CORNERSTONE PLAZA SUBDIVISION

APPLICATION NUMBER 3 DATE December 17, 2020

REQUEST Subdivision

DETAIL SITE PLAN

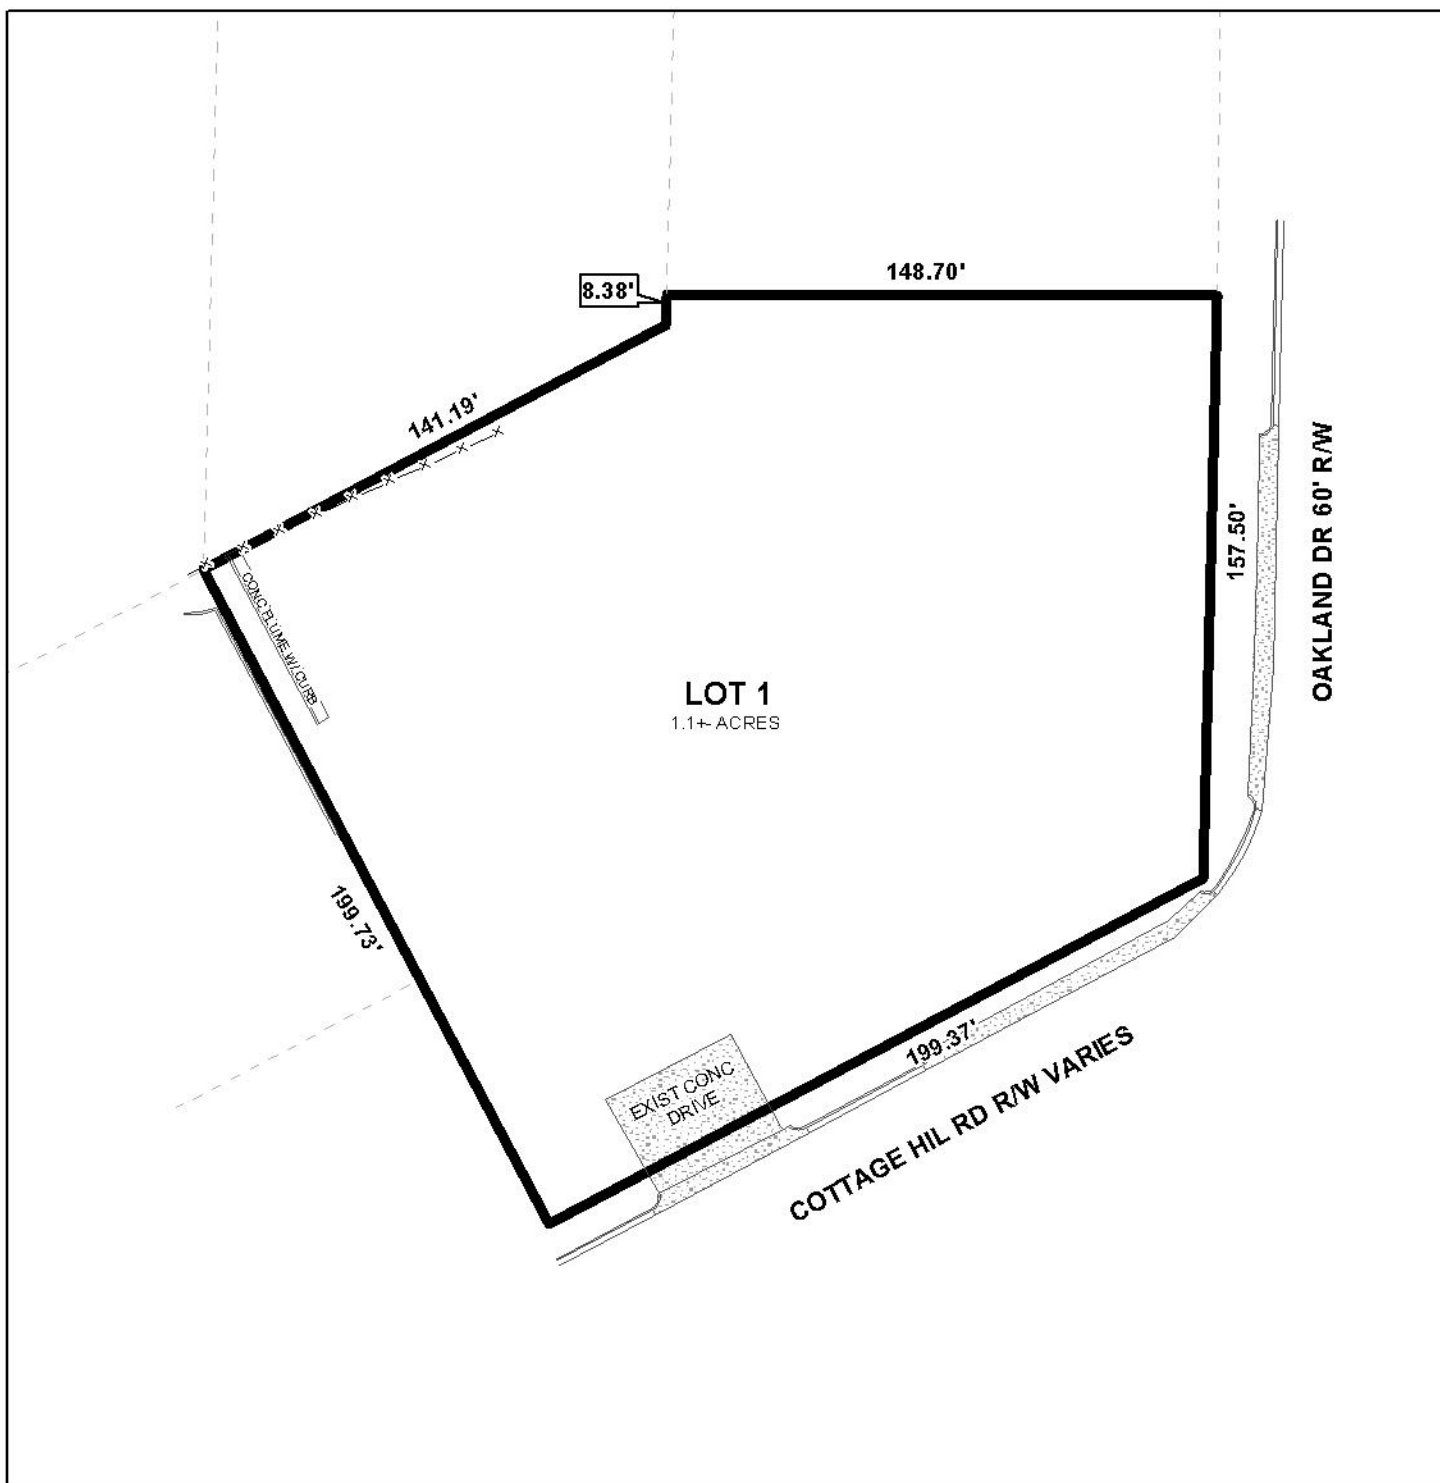
As proposed, Lot 1 fronts both Cottage Hill Road, a major street; and Oakland Drive, a minor street provided with curb and gutter. The preliminary plat labels the Cottage Hill right-of-way as "varies" however per the Major Street Plan this portion of Cottage Hill Road requires a 100' right of way, and as such should be revised on the Final Plat to illustrate 50' from the centerline of Cottage Hill Road providing for dedication as needed. Oakland Drive, is depicted with an adequate right-of-way of 60 feet and should be retained on the Final Plat. As this site is a corner lot, dedication sufficient to comply with Section V.B.16 of the Subdivision Regulations regarding curb radii is also necessary and should be illustrated on the Final Plat.

that the preliminary plat does not illustrate any required setbacks. As such, the Final Plat should be revised to show a 25-foot minimum building setback along both street frontages, adjusted for dedication, if necessary.

No easements are indicated on the preliminary plat. If any easements are recorded on the site they should be indicated and labeled on the Final Plat, and a note should be placed on the Final Plat stating that no structure may be placed or constructed within any easement without permission of the easement holder.

- 1) Revision of the Final Plat to label the right-of-way width for Cottage Hill Road as 100’;
- 2) Dedication to provide 50 feet from the centerline of Cottage Hill Road, if needed;

- 3) Dedication sufficient to provide compliant curb radii at the Northwest corner of Cottage Hill Road and Oakland Drive;
- 4) Revision of the Final Plat to illustrate a 25-foot minimum building setback for Lot 1 along Cottage Hill Road and Oakland Drive, adjusted for dedication, if applicable;

- 5) Retention of the lot size in both square feet and acres, or the furnishing of a table on the Final Plat providing the same information, adjusted for dedication if necessary;

- 6) Placement of a note on the Final Plat stating that no structure may be constructed or placed within any easement without the permission of the easement holder, if applicable;
